Subject: Maverik Gas and Convenience Store Traffic Impact Study

Juan Tabo Blvd. and Copper Ave., North of I-40 Albuquerque, Bernalillo County, New Mexico

This letter is to inform you that the **FINAL** Traffic Impact Study (TIS) for the proposed Maverik Store on the southeast quadrant of Juan Tabo Blvd. and Copper Ave. north of I-40 dated April 3, 2019 has been reviewed.

EXHIBIT A

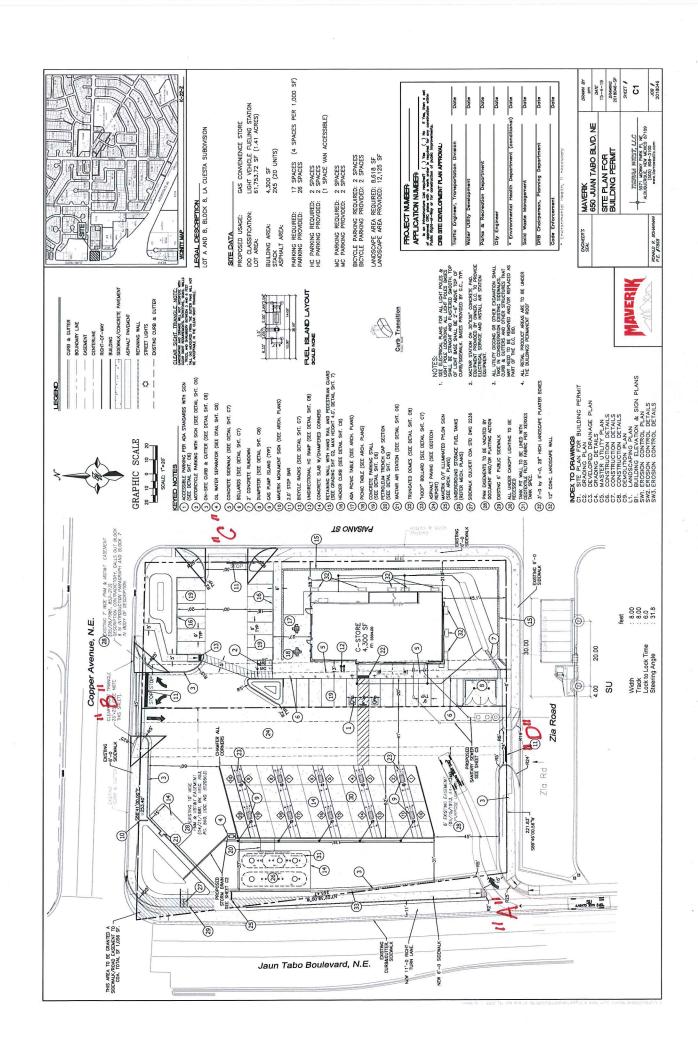
The NMDOT has no objection to the partial Right-In ONLY access at Driveway "A" on Juan Tabo Blvd. located about 450-feet north of the I-40 westbound off-ramp at Juan Tabo. The proposed Maverik Store site plan is shown in Exhibit A. NMDOT gives final concurrence of this development given the conditions below are met. This TIS proposed the recommendations shown in Exhibit B.

- 1. The proposed access break on the NMDOT's access control line on Juan Tabo Blvd. shall be approved by the State's Access Control Committee. The property owner shall follow the State's procedure for the official access break prior to construction of any work.

- 2. The property owner shall submit a Commercial Driveway Application for Driveway "A" as shown in Exhibit A.
- 3. The development shall install a northbound right turn deceleration lane on Juan Tabo Blvd. at Copper Ave. of about 640 feet in length.
